Attachment 2 to AEP:NRC:0894U

EXISTING TECHNICAL SPECIFICATIONS
FOR DONALD C. COOK NUCLEAR PLANT UNIT 2
MARKED TO REFLECT PROPOSED CHANGES

COOK NUCLEAR PLANT - UNIT 2

PROPOSED TECHNICAL SPECIFICATIONS
FOR DONALD C. COOK NUCLEAR PLANT UNIT 2

FIGURE 3.4-2

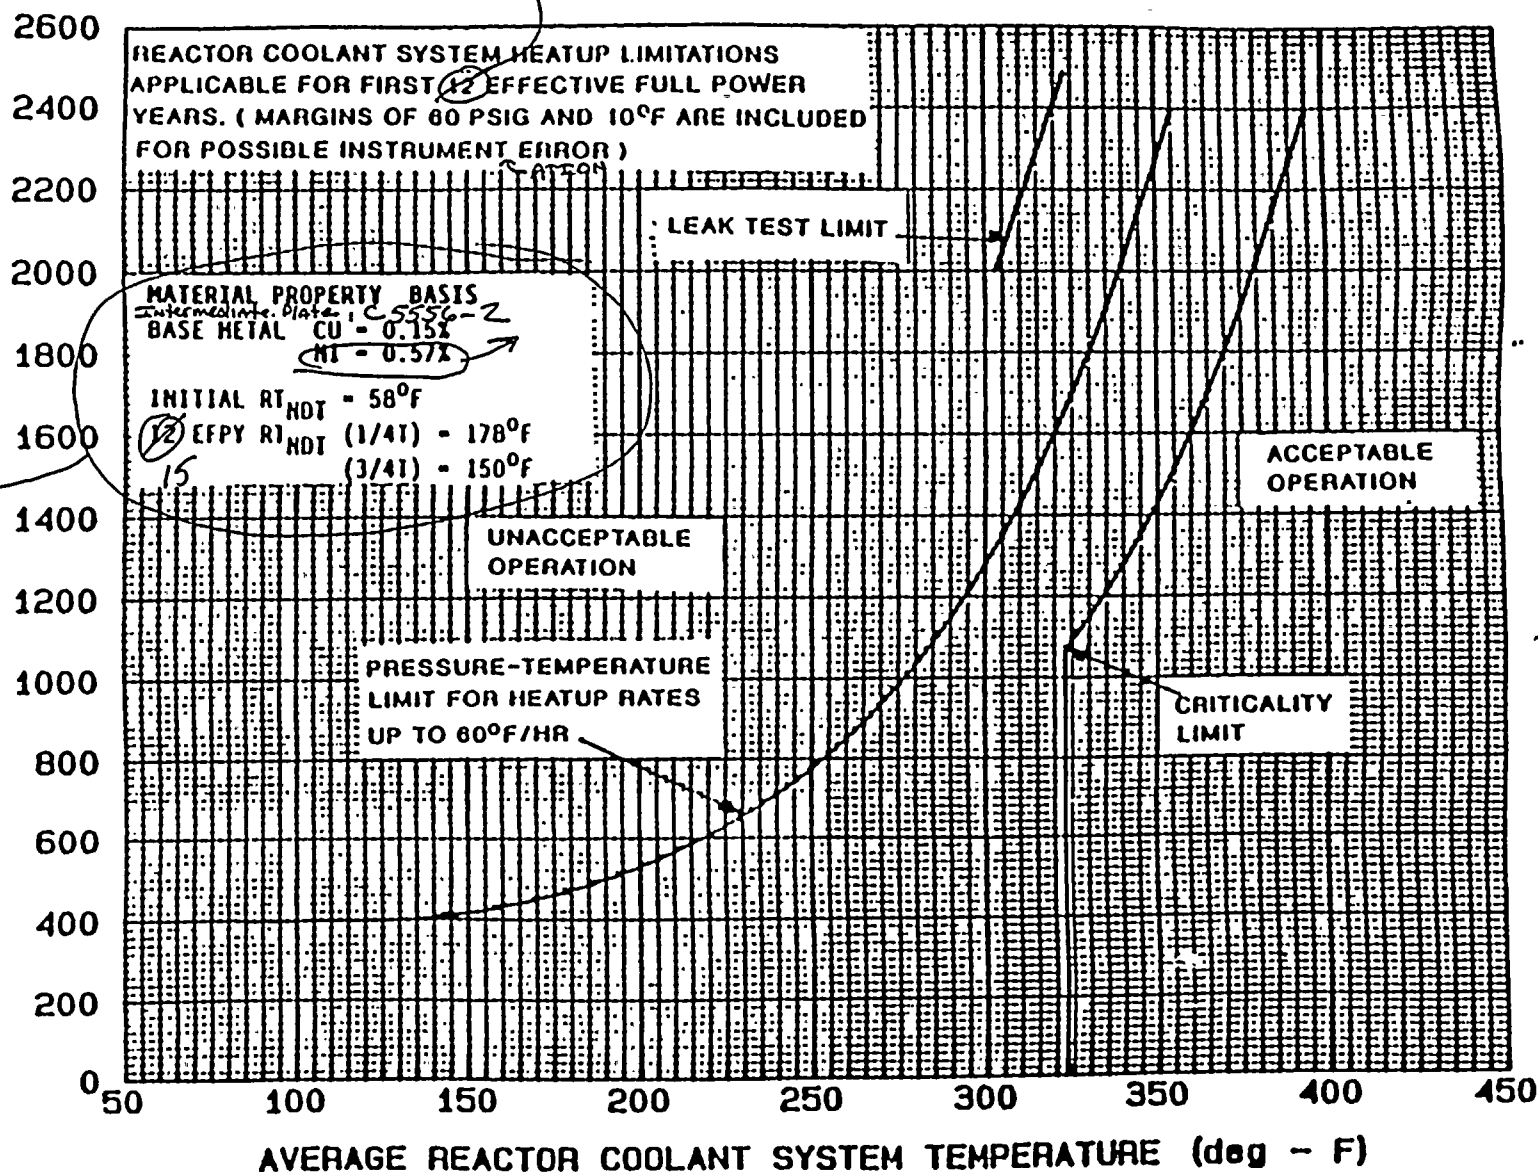
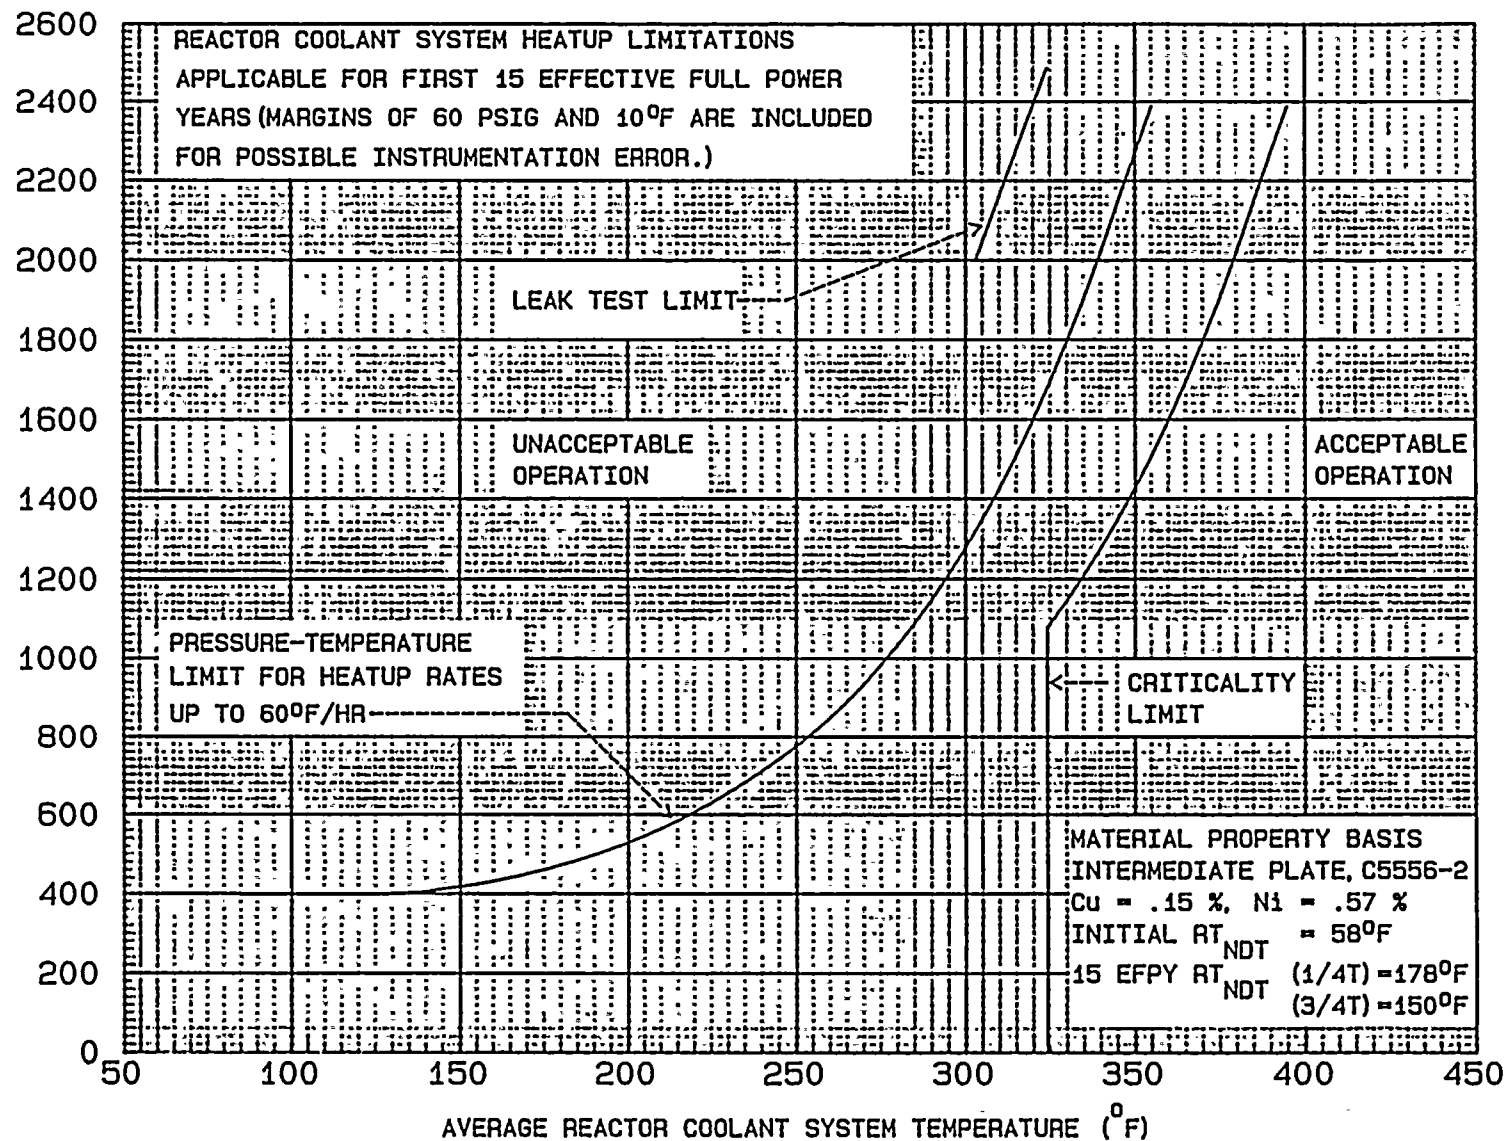
Move
to
Bottom
Right
of Curve

The heatup limit curve, Figure 3.4-2, is a composite curve which was prepared by determining the most conservative case, with either the inside or outside wall controlling, for any heatup rate up to 60°F per hour. The cooldown limit curves of Figure 3.4-3 are composite curves which were prepared based upon the same type analysis with the exception that the controlling location is always the inside wall where the cooldown thermal gradients tend to produce tensile stresses while producing compressive stresses at the outside wall. The heatup and cooldown curves were prepared based on the most limiting value of the predicted adjusted reference temperature at the end of 12 EFPY.

Insert No. 1 → The 12 EFPY heatup and cooldown curves were developed based on the following:

The heatup limit curve, Figure 3.4.2, is a composite curve which was prepared by determining the most conservative case, with either the inside or outside wall controlling, for any heatup rate up to 60°F per hour. The cooldown limit curves of Figure 3.4-3 are composite curves which were prepared based upon the same type analysis with the exception that the controlling location is always the inside wall where the cooldown thermal gradients tend to produce tensile stresses while producing compressive stresses at the outside wall. The heatup and cooldown curves were prepared based on the most limiting value of the predicted adjusted reference temperature at the end of 15 EFPY.

The 15 EFPY heatup and cooldown curves were developed based on the following:

1. The intermediate shellplate, C5556-2, is the limiting material as determined by position 1 of Regulatory Guide 1.99, Revision 2, with a Cu and Ni content of 0.15% and 0.57%, respectively.
2. The fluence values contained in Table 6-14 of Westinghouse WCAP-13515 report, "Analysis of Capsule U From the Indiana Michigan Power Company D. C. Cook Unit 2 Reactor Vessel Radiation Surveillance Program", dated February 1993.

FIGURE 3.4-3

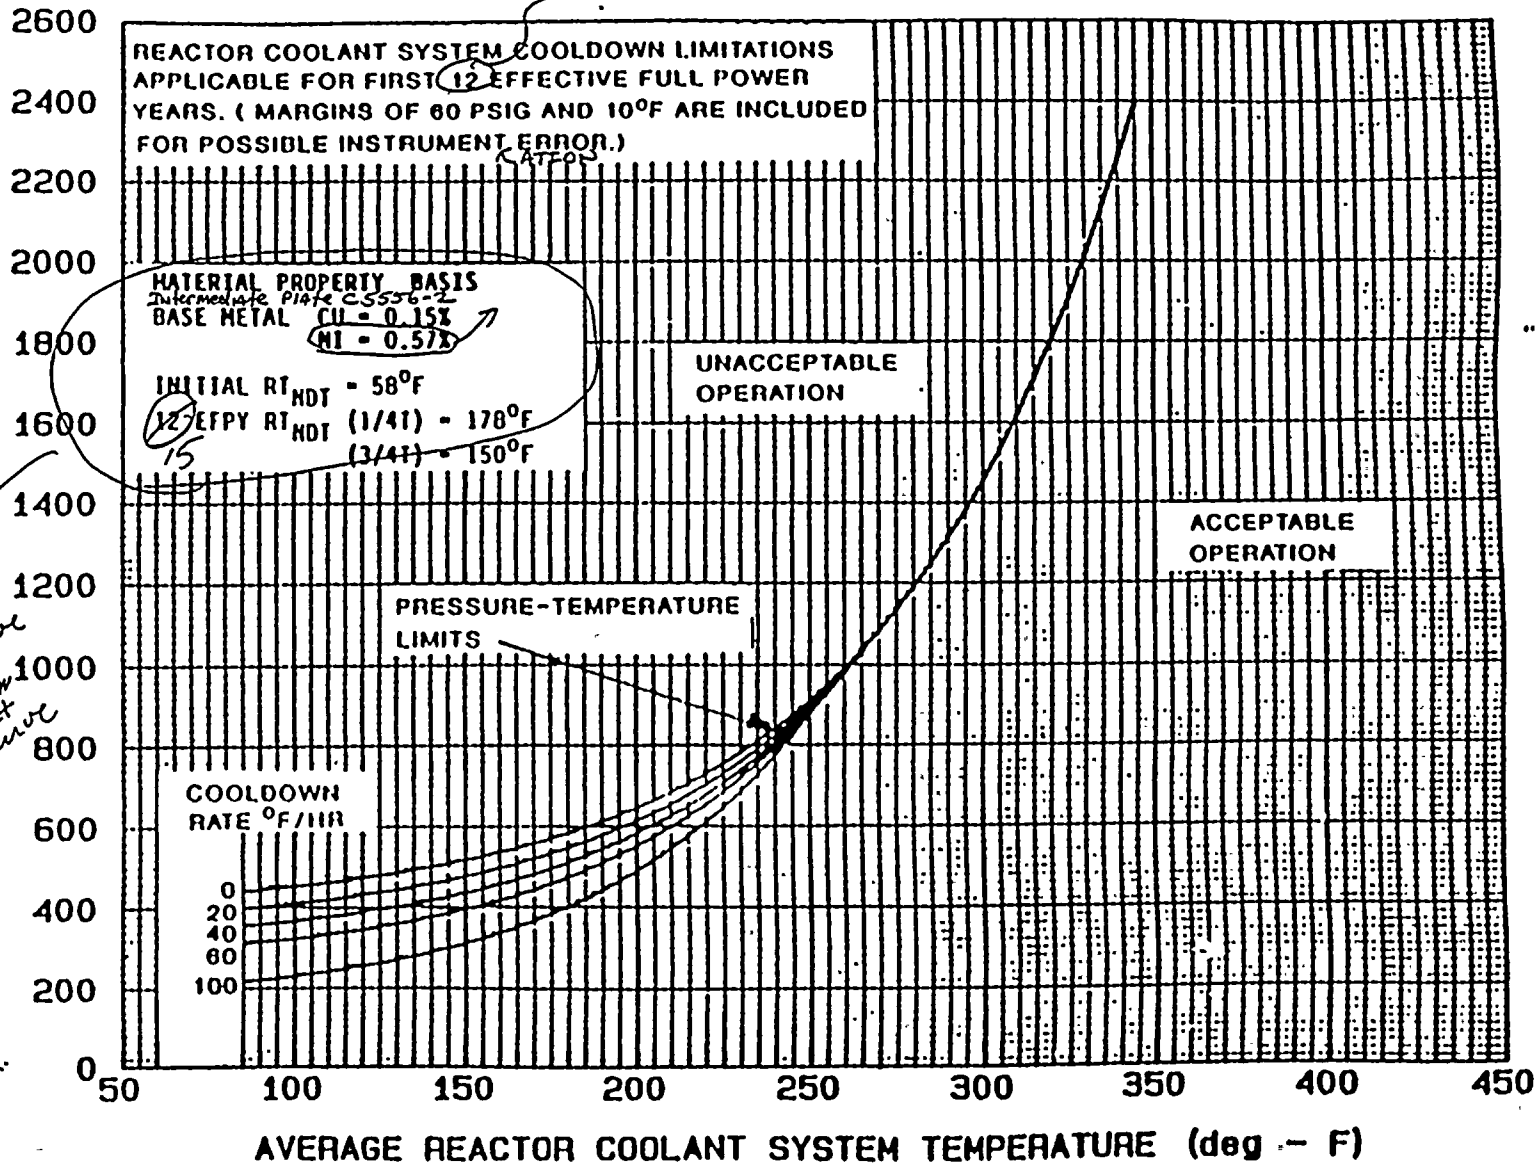
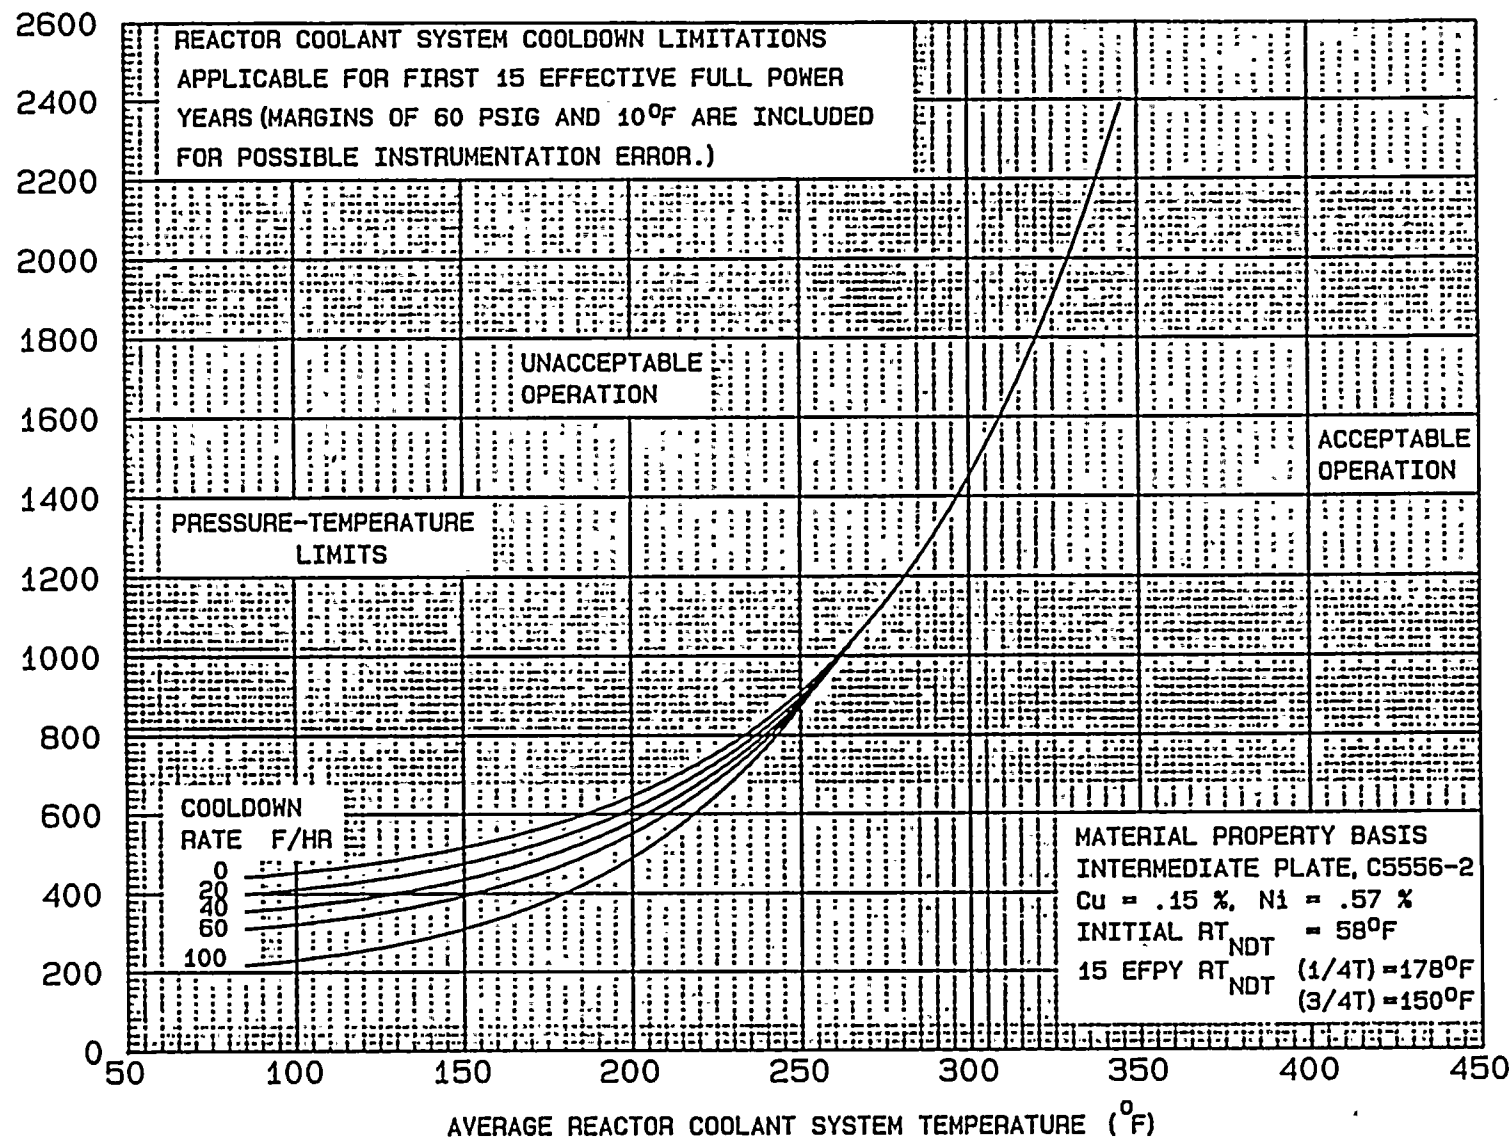
The heatup and cooldown limit curves of Figures 3.4-2 and 3.4-3 include predicted adjustments for this shift in RT_{NDT} at the end of 12 EFPY, as well as adjustments for possible errors in the pressure and temperature sensing instruments.

The heatup and cooldown limit curves of Figures 3.4-2 and 3.4-3 include predicted adjustments for this shift in RT_{NDT} at the end of 15 EFPY, as well as adjustments for possible errors in the pressure and temperature sensing instruments.
